ADDENDUM NO. 1

DATE: August 15, 2018
FROM: City of Grand Junction Purchasing Division
TO: All Offerors
RE: Lewis Wash Bridge Replacement (Re-Bid) IFB-4548-18-DH

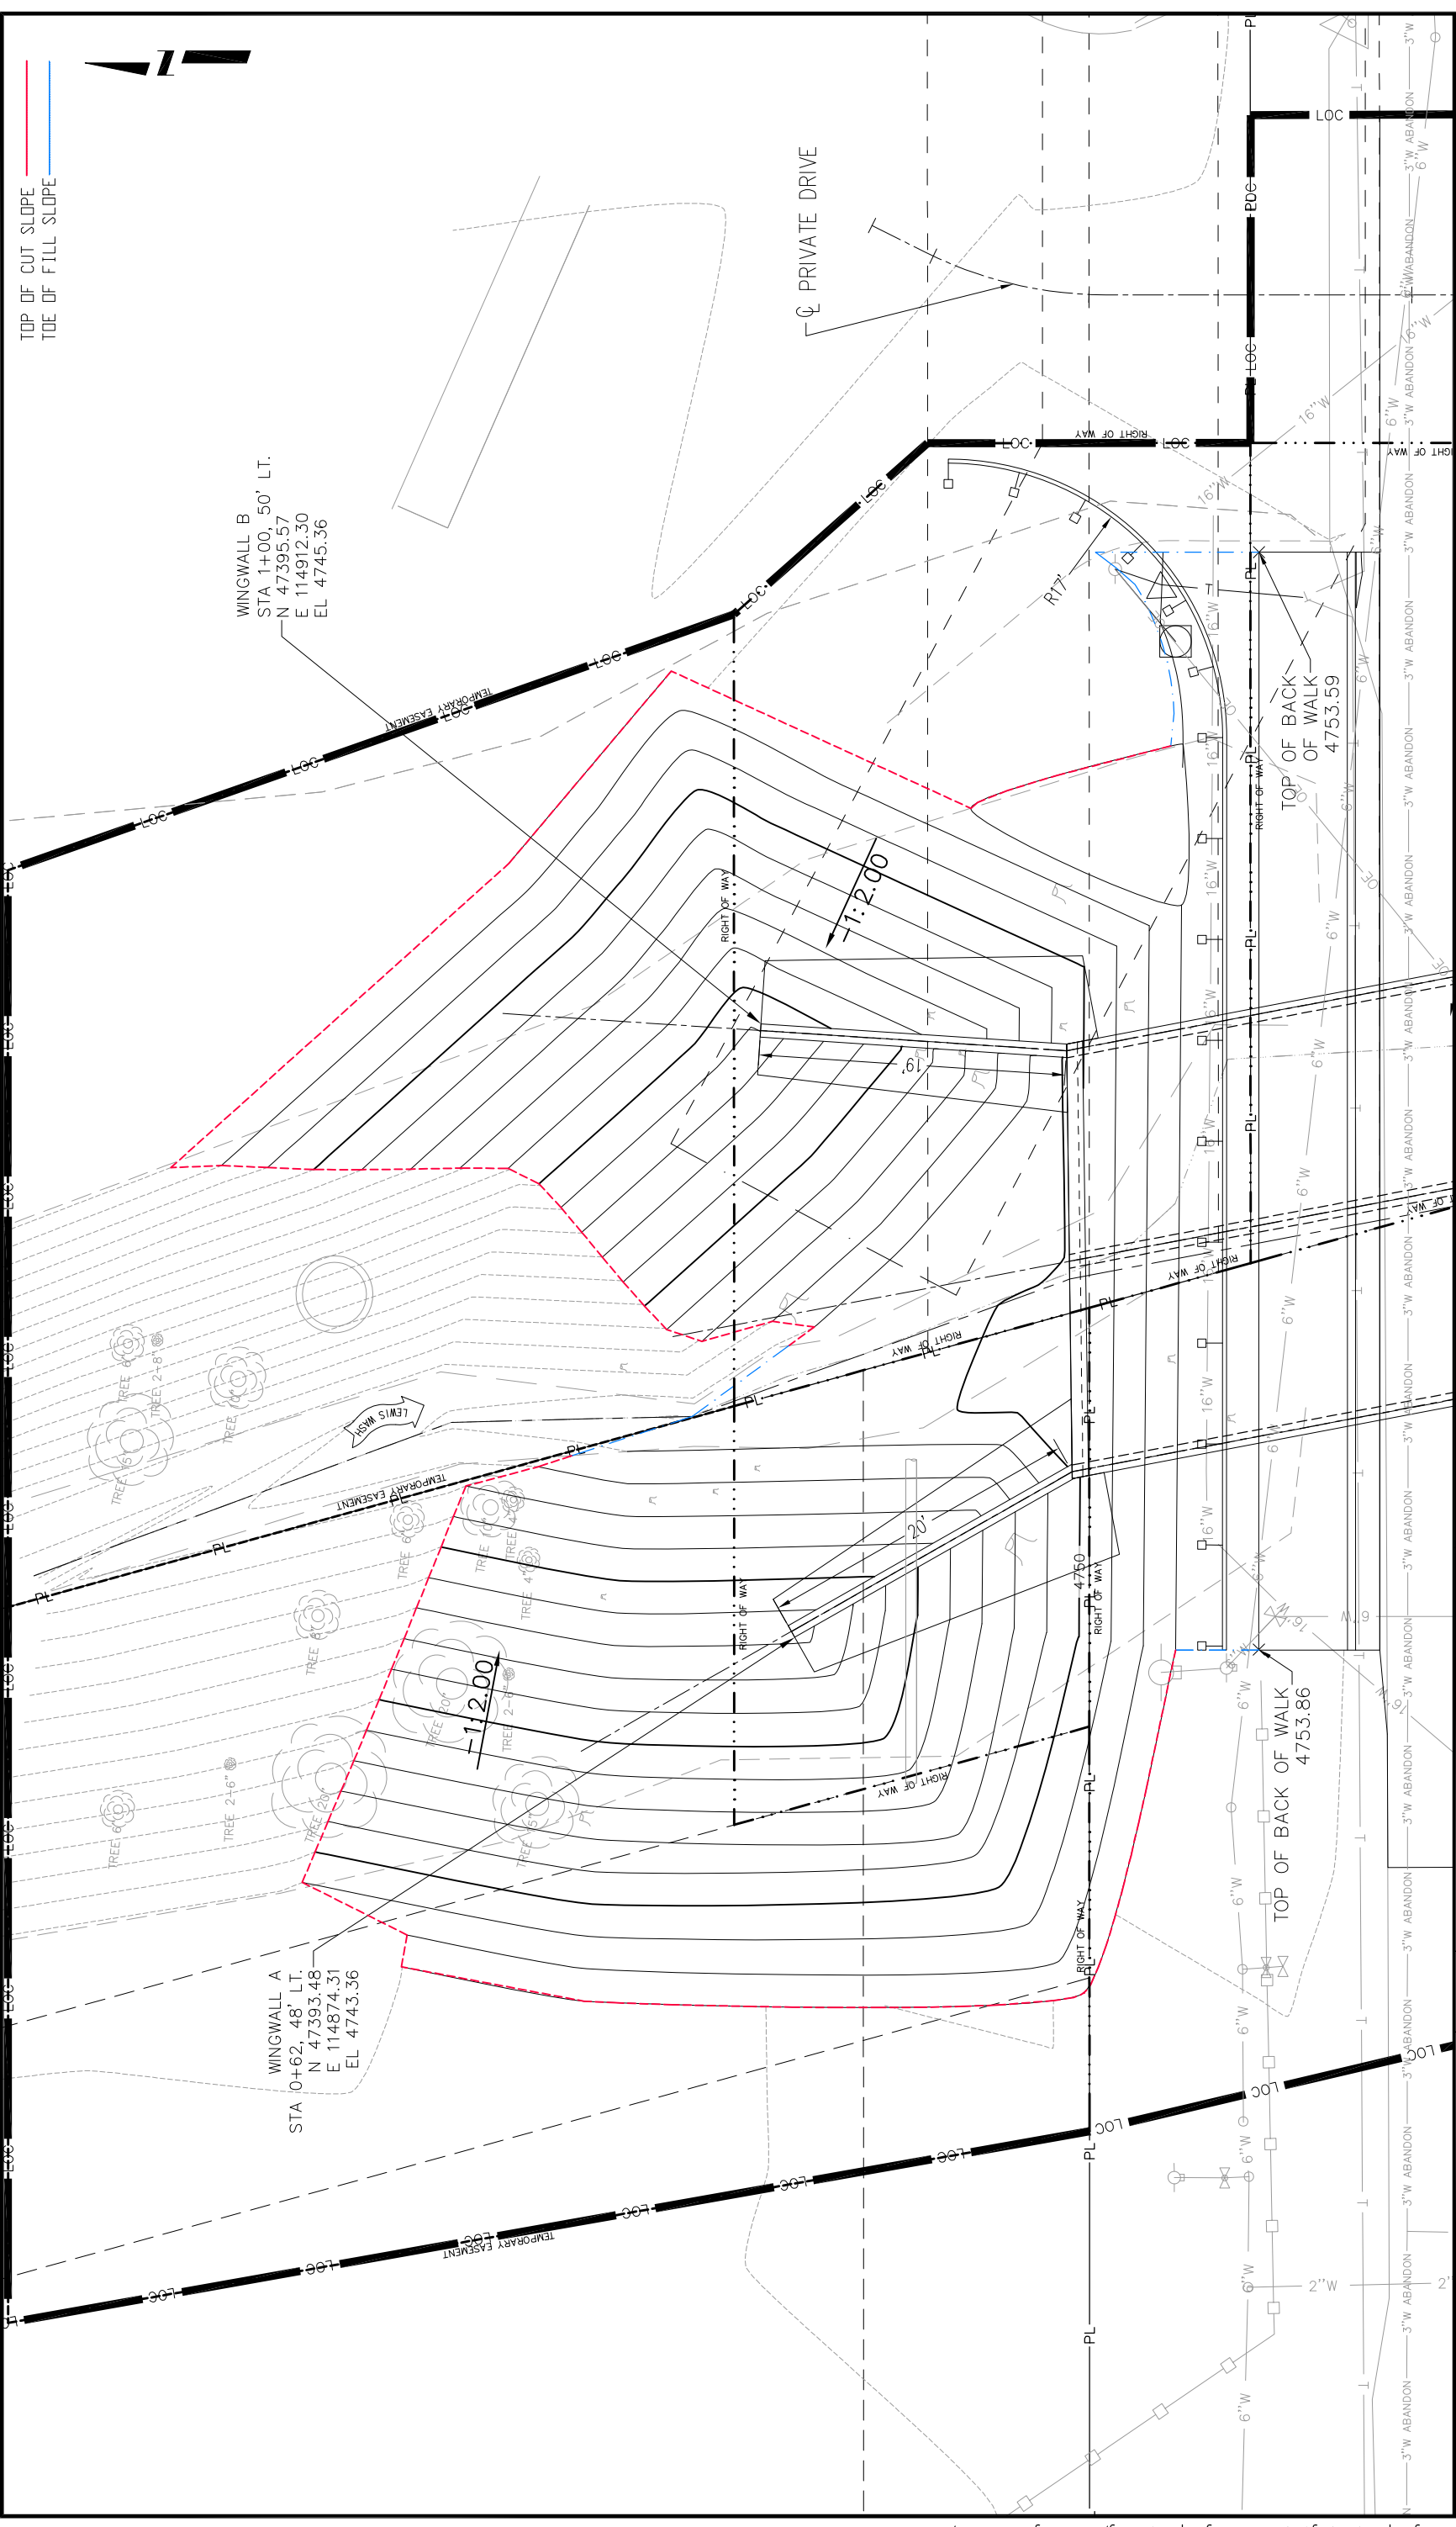
4. Q. Please provide contour elevations on the grading drawing.
 - A. Existing and proposed grading contour elevations will be shown in the drawings. The drawings affected will be re-issued under Addendum #1.

<table><tr> <th>Date:</th> <th>Comments</th> <th>Init.</th> </tr><tr> <td>2018-08-14</td> <td>Proposed Contours Shown</td> <td>KA</td> </tr></table>

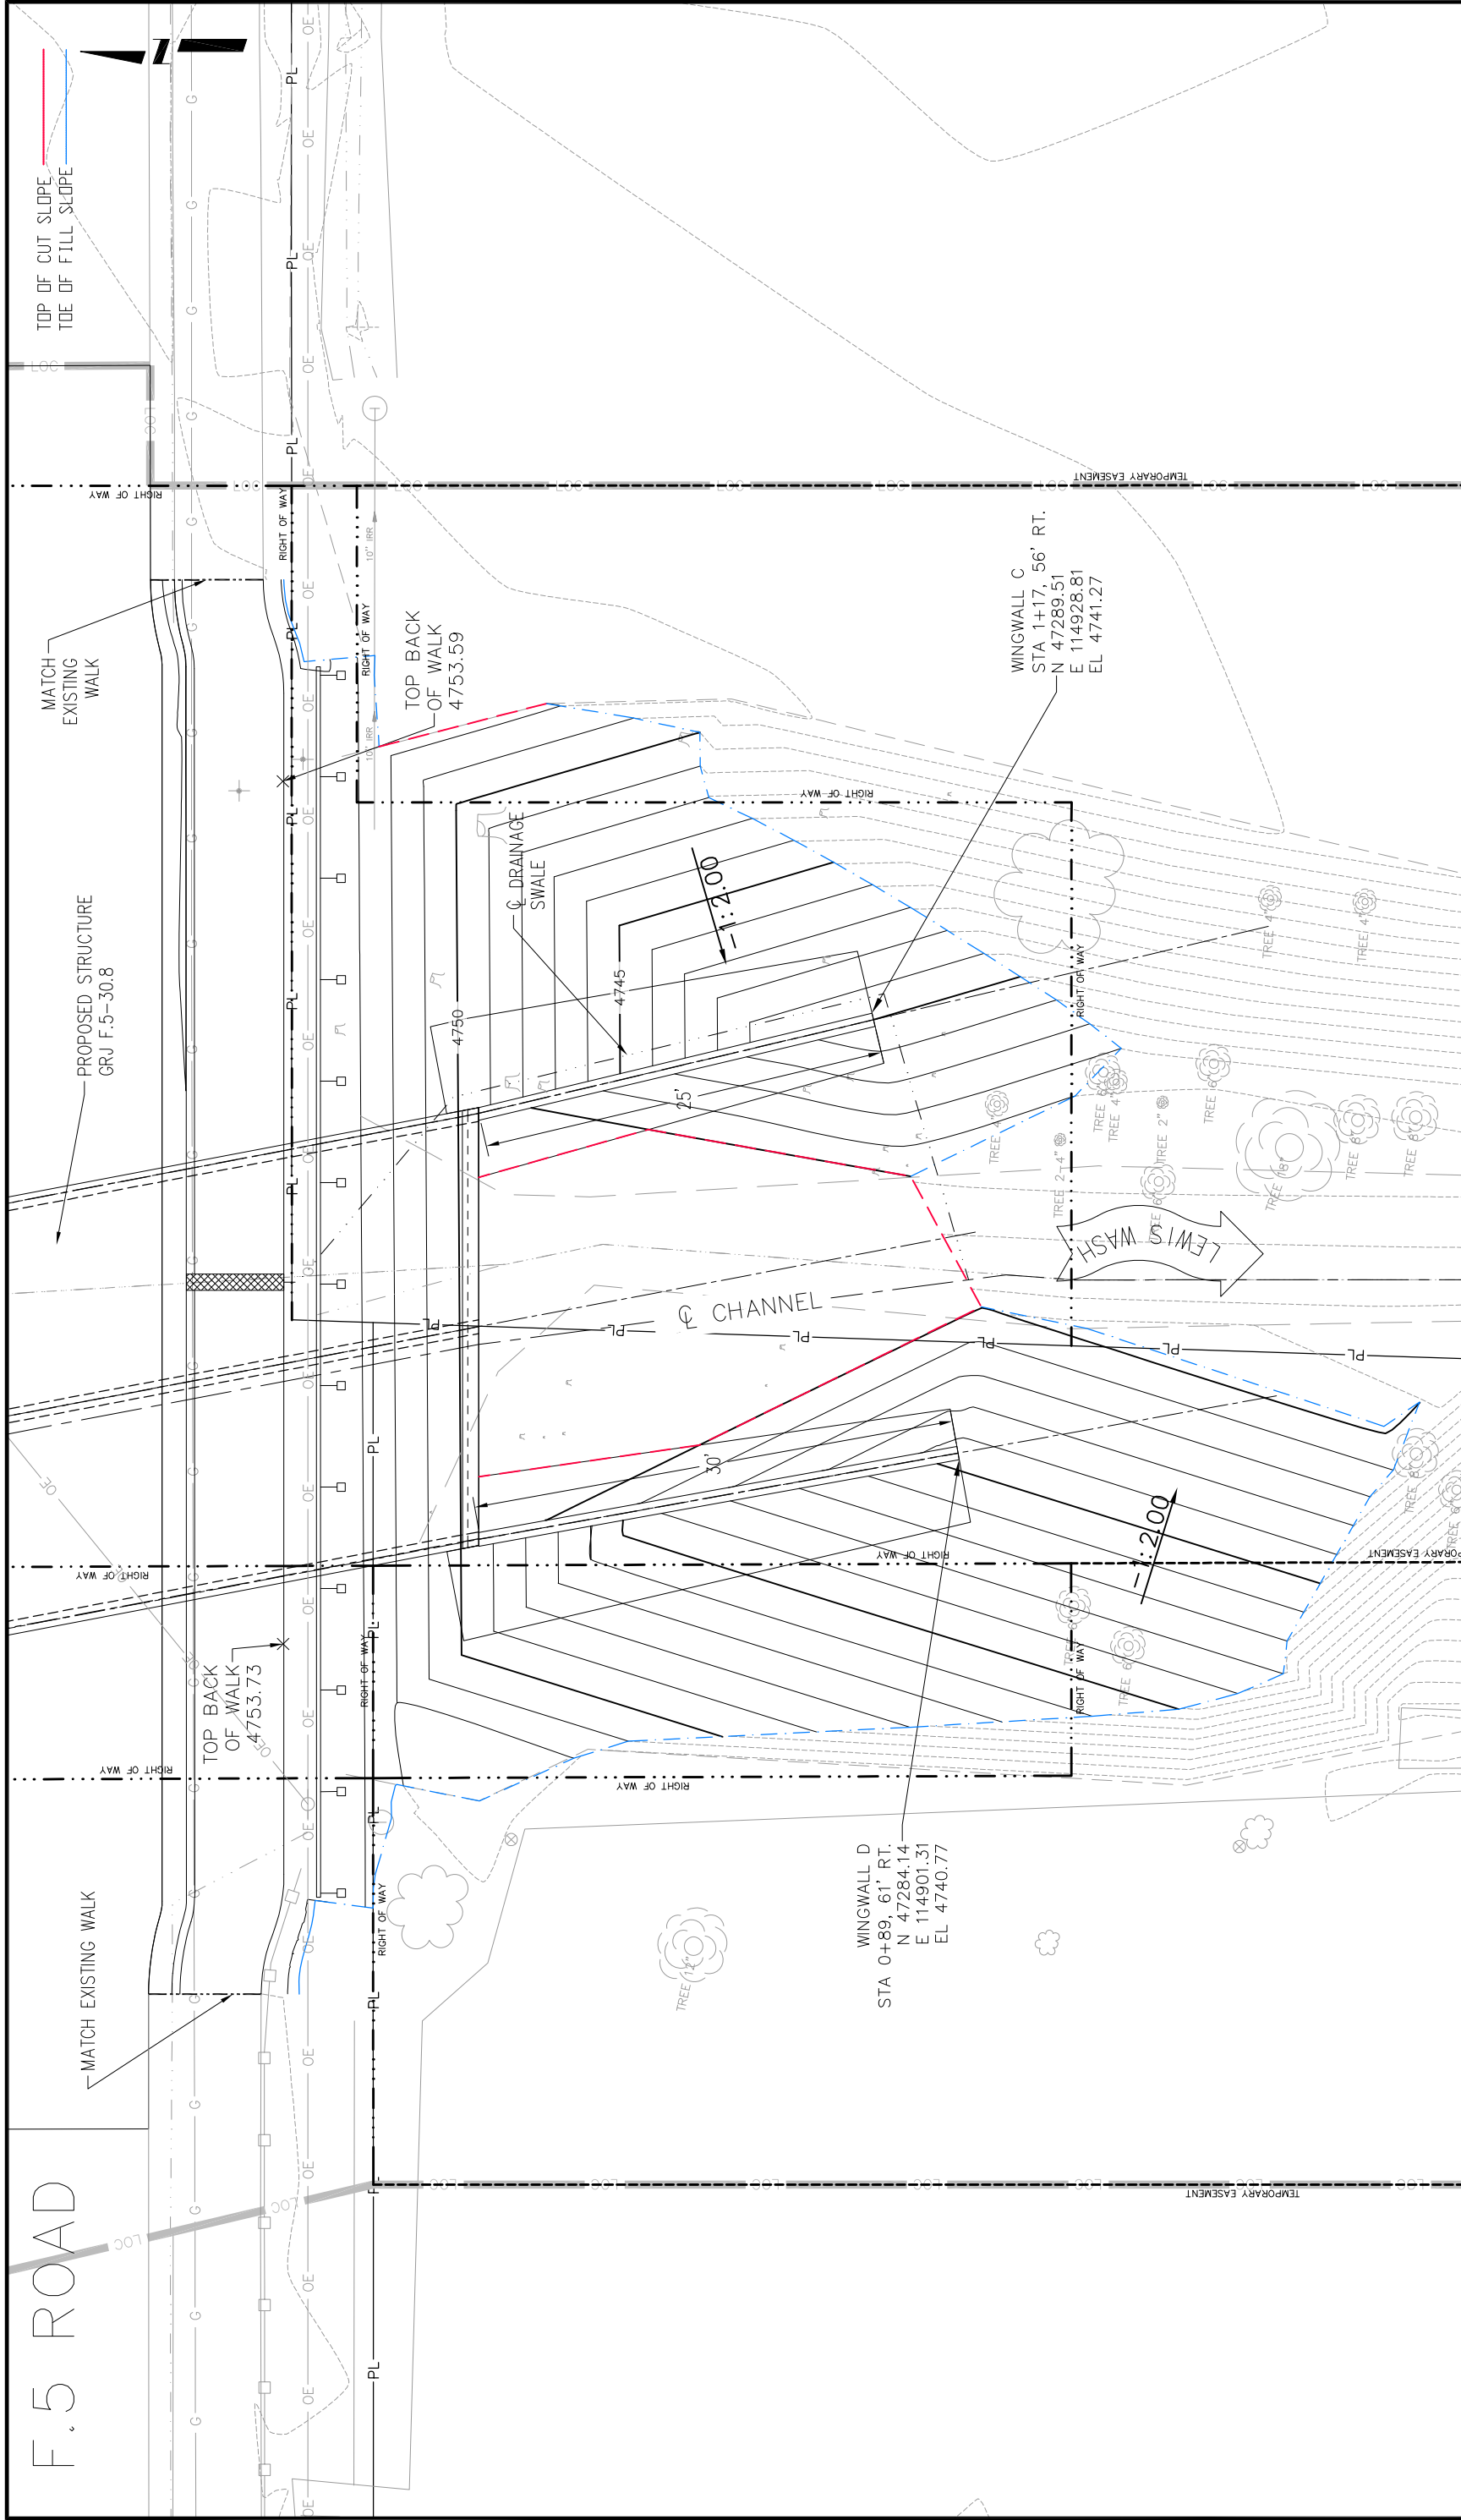
<table><tr> <th>Date:</th> <th>Comments</th> <th>Init.</th> </tr><tr> <td>2018-08-14</td> <td>Proposed Contours Shown</td> <td>KA</td> </tr></table>

GRADING PLAN

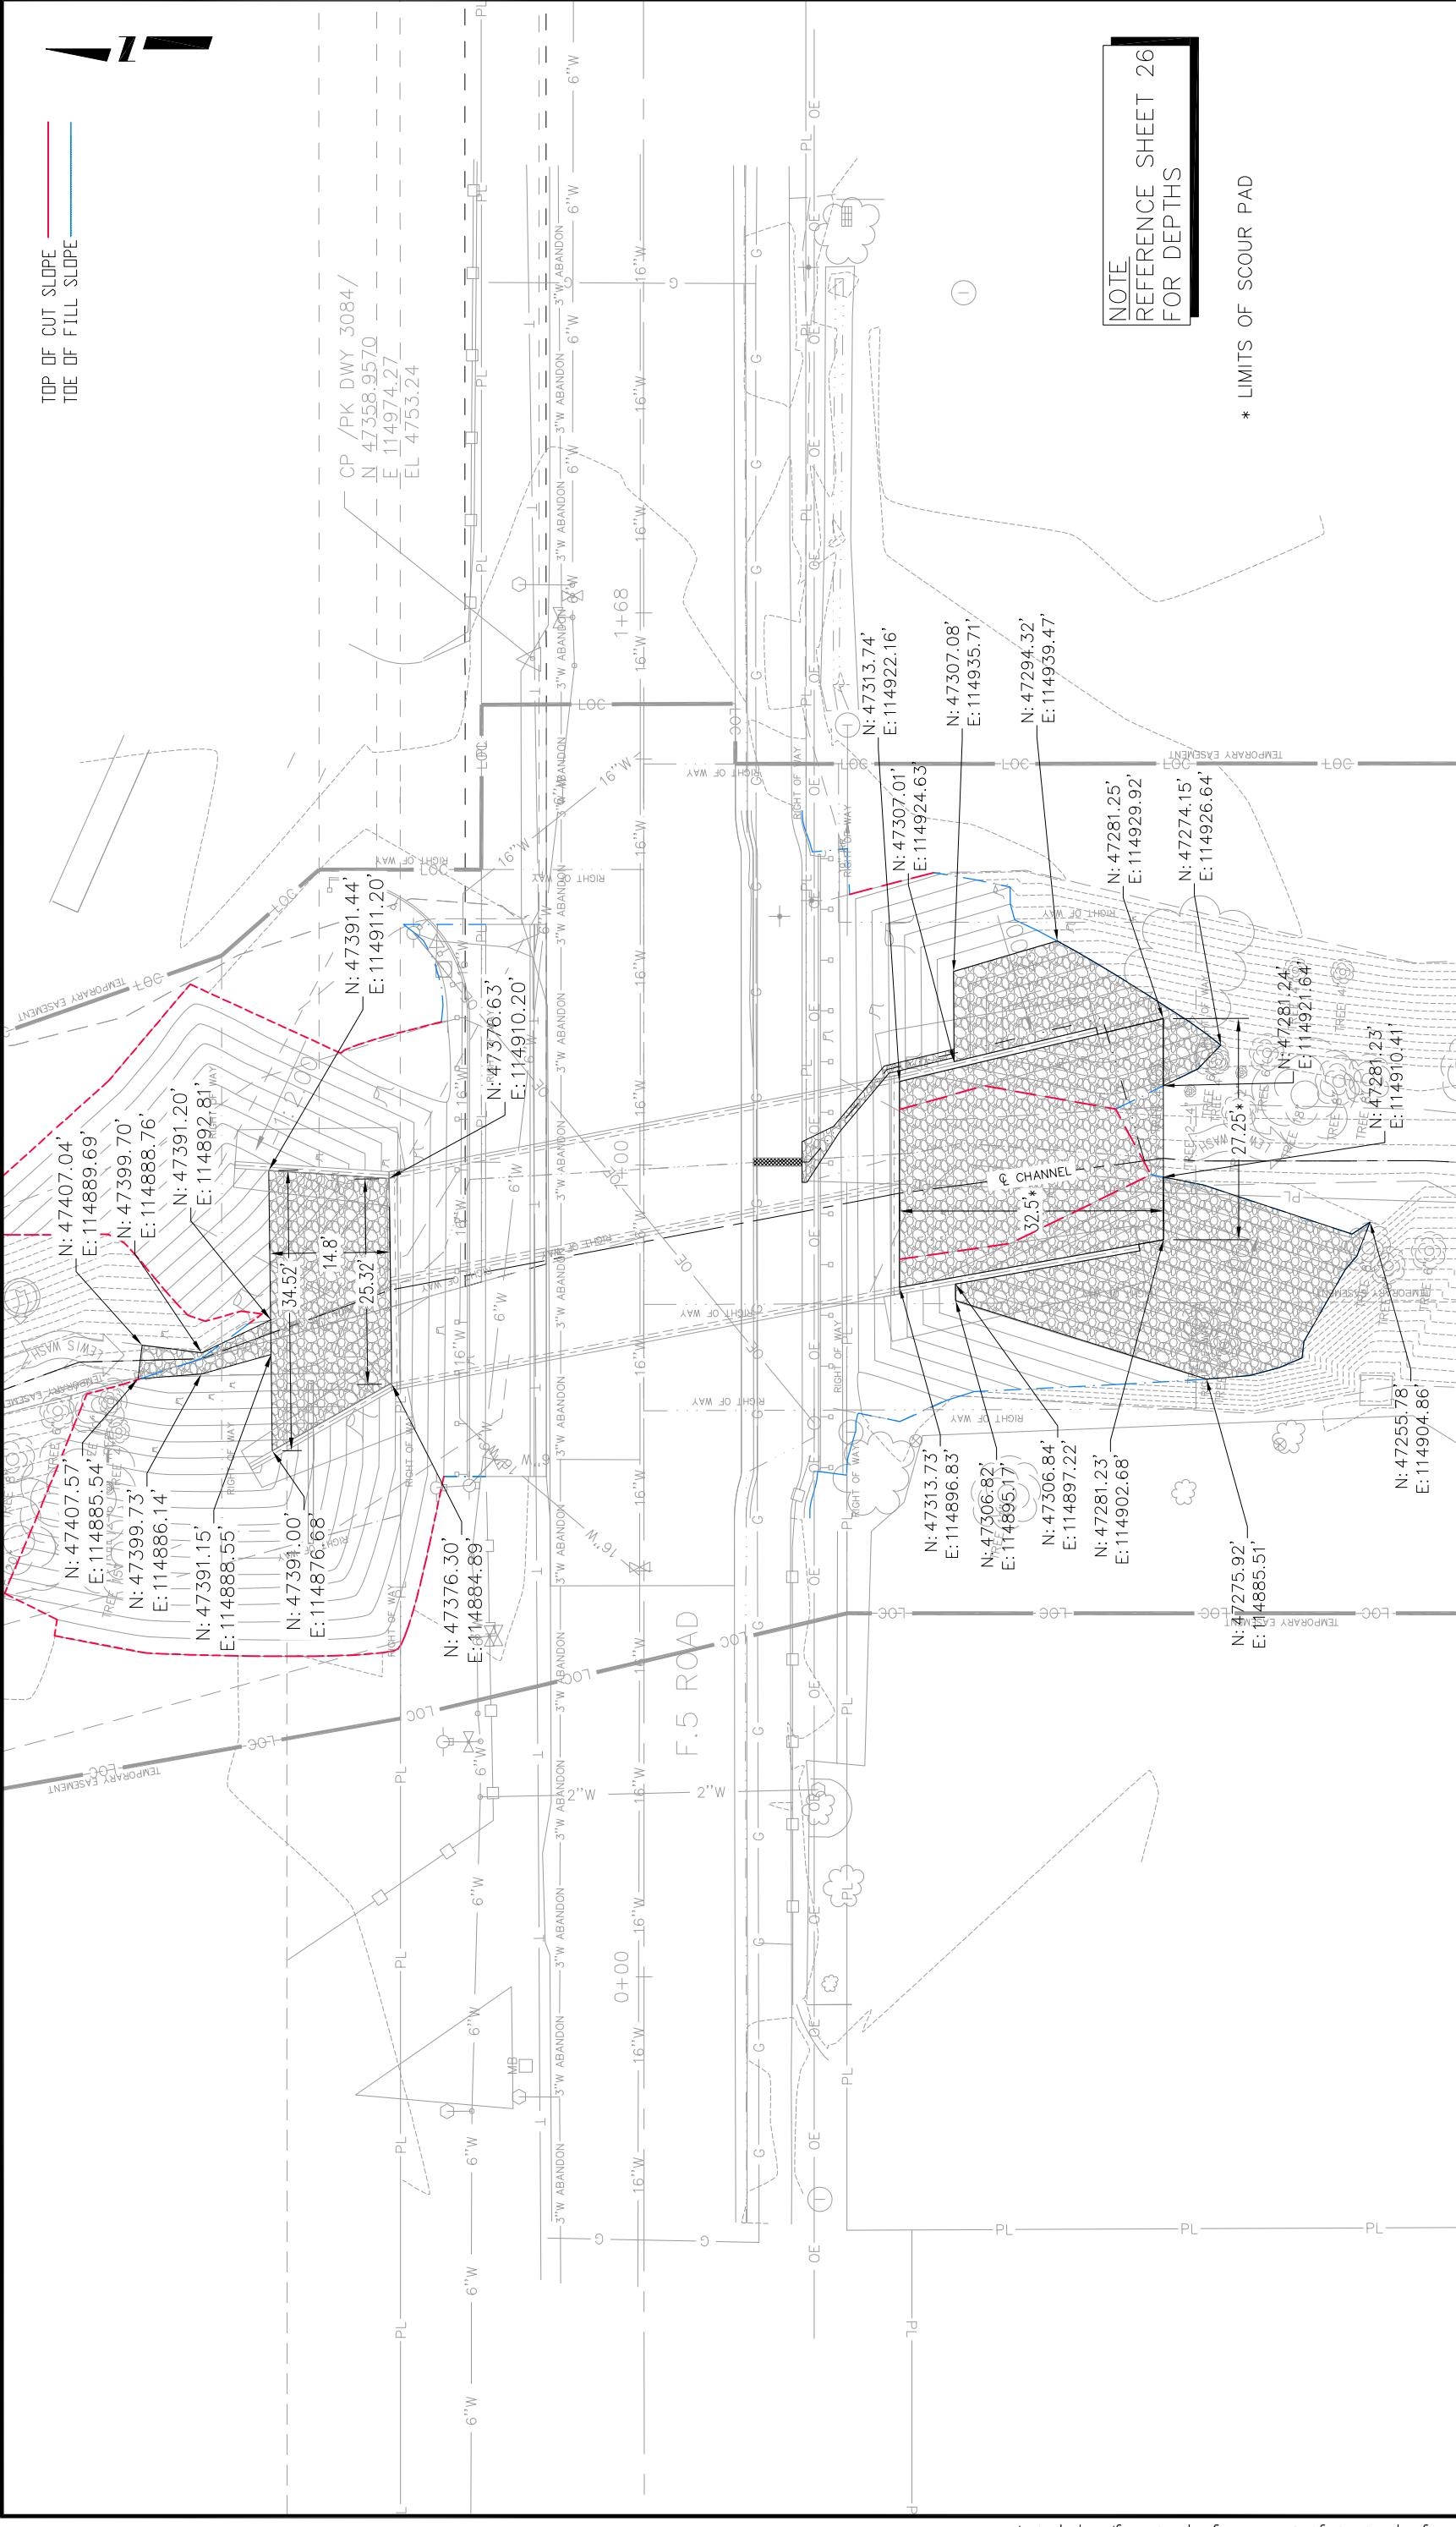
Date:	Comments	Init.
2018-08-14	Proposed Contours Shown	KA
